Staff Report

Panera Bread
PUD Development Plan
An Amendment to a Portion of The Ridge at Dillon Planned Unit
Development

Prepared by the Town of Dillon for the Planning and Zoning Commission

Figure 1. Dillon Ridge Road Stacking Distance Exhibit

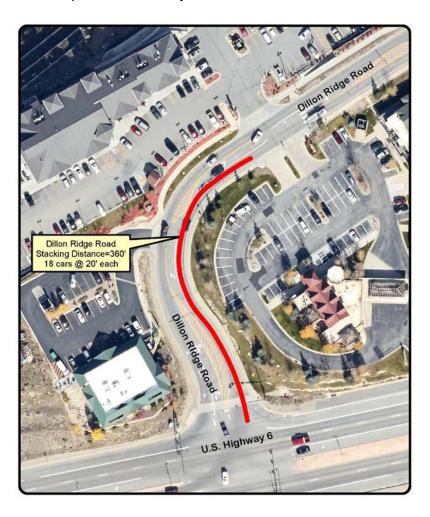
The vehicle stacking distance between U.S. 6 and the intersection is 360 feet. At 20 feet per vehicle this will easily accommodate a minimum of 18 cars and the Town believes this will be more than adequate on most days.
